Shoalhaven Traffic Committee

Agenda

TC23.19 Signage, Linemarking and Roundabout Plans - Lot A and B DP 156987 - 122 and 124 Plunkett Street - Nowra - PN(3736)

124 & 122 Plunkett St, NOWRA - Lot A & B DP 156987 – Signage, linemarking and roundabout construction at the intersection of Plunkett Street and Journal Street, Nowra.

DRAWING TITLE
ROUNDBOUT LINE MARKING AND SIGNAGE

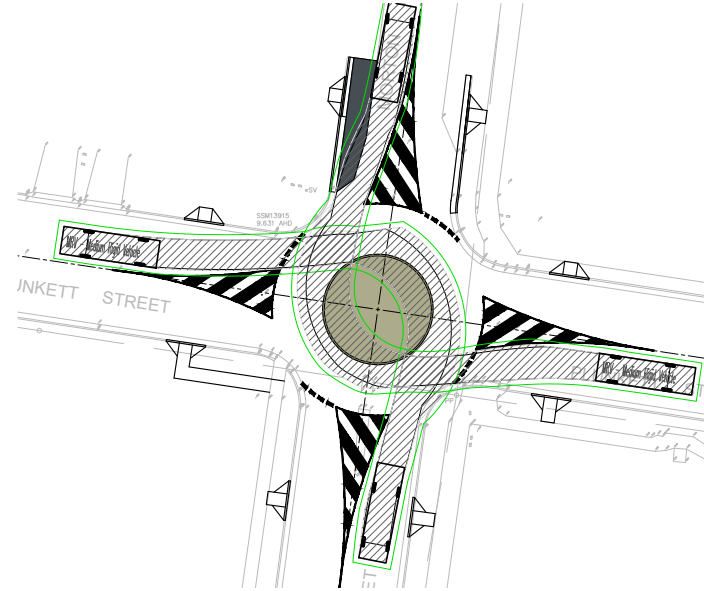
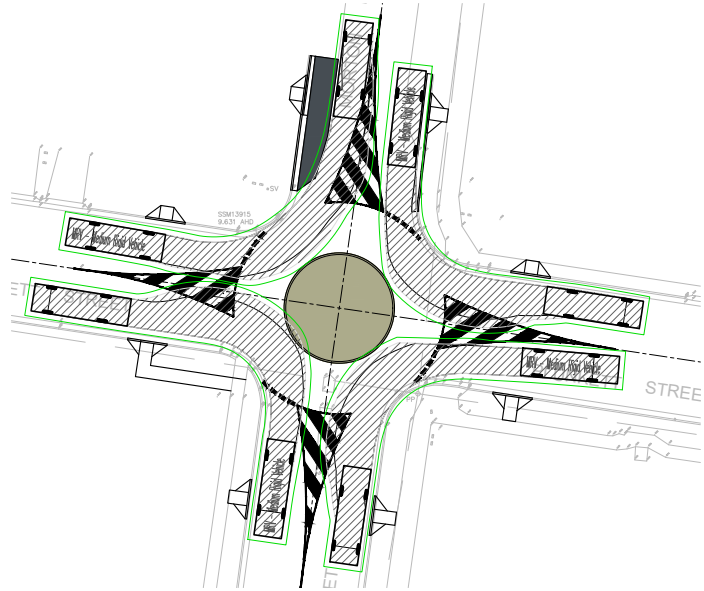
1. The Chief Executive Officer (Director City Services) be advised that the Shoalhaven Traffic Committee has no objection to the proposed roundabout located at the intersection of Plunkett Street and Journal Street, associated with the development of Lot A and B DP 156987 – Plunkett Street, Nowra (per development consent condition 29), as per Plan No D23/41579, D23/41585, D23/41586 and D23/128871 subject to the following:

- a. The existing signage (street name and no through road) to be retained where possible else relocated outside of vehicle turn movements and pavement works.

- b. Kerb ramps to be designed and constructed in accordance with AS 1428.1 Section 7.7. Specifically, the existing north-eastern corner footpath is to be relocated to suit the proposed kerb ramp including incorporating the 1.5m by 2m minimum upper landing area behind the ramp as per Figure 23(A) of the standard. Where there is currently no existing path at the north-western corner of the intersection, the landing area is to be incorporated behind the kerb ramps.
